2017 ROADWAY STABILIZATION PROJECT

ADDENDUM No. 1

January 9, 2017

DATE: 01/17	JOB NO. —
DWG. SK1	SCALE: 1"=50'

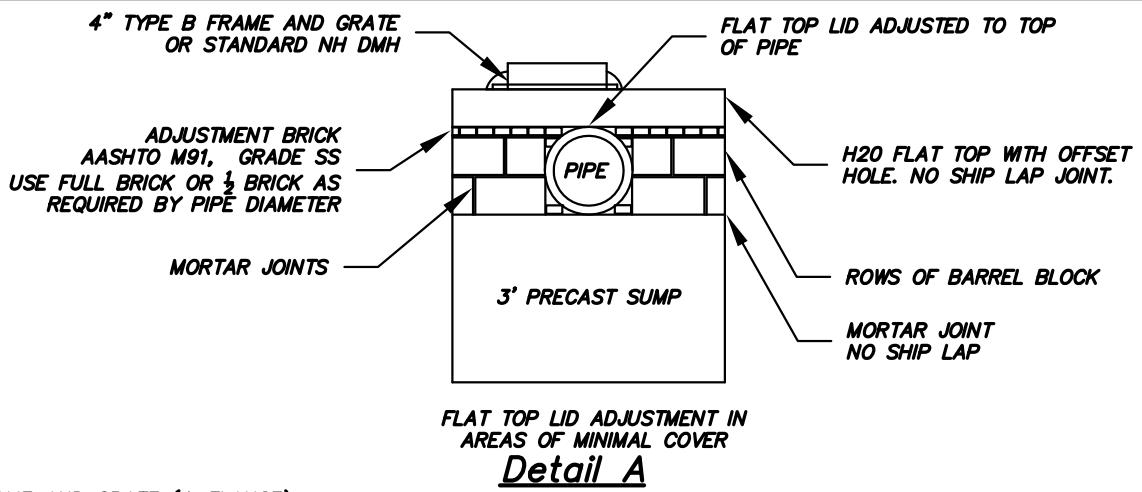
3. **Insert** the attached sketch SK1 and details D7 and D8 into Appendix A in the CONTRACT DOCUMENTS.

The sketch and details provide for replacement of a shallow 375-foot drainage run inclusive of barrel block drain structures, headwalls and stone protection aprons. The sketch also provides for additional excavation at the outfall and erosion control measures. Quantities have been updated as stated in Item #1 and #2 above.
